Index 521-660 Light Pole Pedestal – Bridge

COMMENTARY

COMMENTS AND RESPONSES

DETAIL "A"

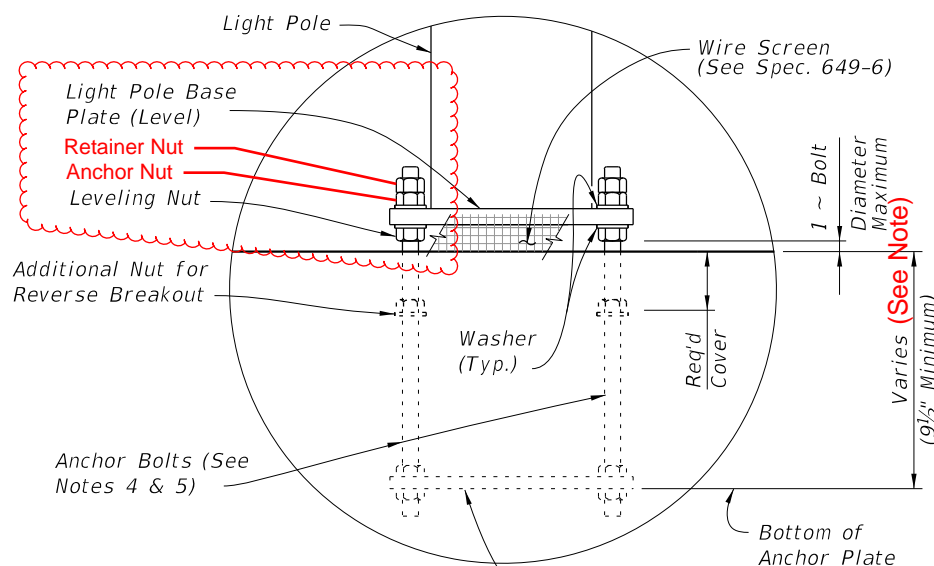
Sheet 4: We labeled the anchor bolt nuts to correspond with the Spec. We eliminated the anchor bolt table because it was from the ground application and gave the impression that all the configurations in the table were designed for for bridge mounted poles which was not the case.

COMMENT: Will additional anchor bolt information similar to the previous Table 1 information be developed for the revised Index 521-660? If not there will be many bridge applications without a typical anchor bolt detail resulting in many different anchor bolt details being developed by different EOR's.

~~TABLE 1 - DESIGN LIMITATIONS FOR ANCHOR BOLTS (1" Dia.)~~

RESPONSE: Note 4 indicates the diameter of the anchor bolt. I will add information to that note about the depth. The depth is a min. 9.5" but may longer as necessary depending on the option used in order to not conflict with rebar. Must maintain bottom cover.

CHANGE MADE TO INDEX: Sheet 4 will be updated to include a note about the depth of the anchor bolt.

Note: Min. anchor bolt embed is 9 1/2". Max embed must maintain min. required bottom cover. Anchor bolt embed max. may be as long as required for constructability depending on which pedestal option is used.
